Permit Evaluation and Recommendations

Prepared for Carmel Olefins
27/12/17

Figure 1. DE vs S/HC Ratio for a variety of flares over a range of conditions and gas compositions. Color bar represents DE > 98%. Data consolidated from various EPA mandated tests 2009-Present.

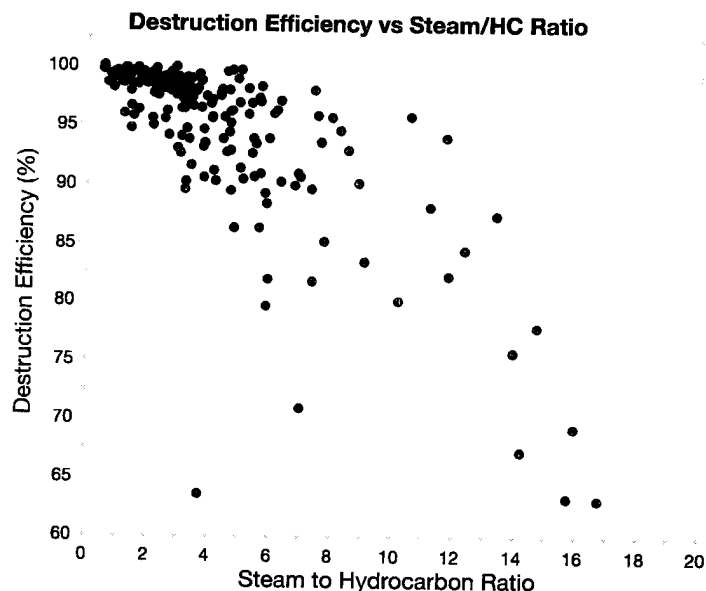
Other language in the draft permit suggests that a steam to gas or steam to hydrocarbon ratio is an appropriate method of assessing oversteaming (although no specific value is given). However, the research suggests that any type of steam ratio is unreliable for predicting high DE. Figure 1 shows a summary of several tests on several flares with a variety of flare gas compositions.

Note that DE > 98% can occur anywhere from a S/HC = ~1 to S/HC = ~5 depending on the flare and gas composition. Also note that DE falls off at very different rates for different tests as well. For flare gas that is very consistent in composition, it may be possible to develop an effective S/HC ratio as an indicator of high DE. For flares with varying composition, this is likely not possible. Also, using a steam to hydrocarbon ratio ignores the significant contribution of even small amounts of hydrogen in the flare gas. Hydrogen has an outsized effect on flare DE compared to its heating value. It also acts as a smoke suppressor meaning less steam is necessary when hydrogen is present.

Recommendation: Develop a clear specification that defines oversteaming to eliminate any potential for uncertainty as to when the flare is operating with the appropriate amount of steam and when it is not.
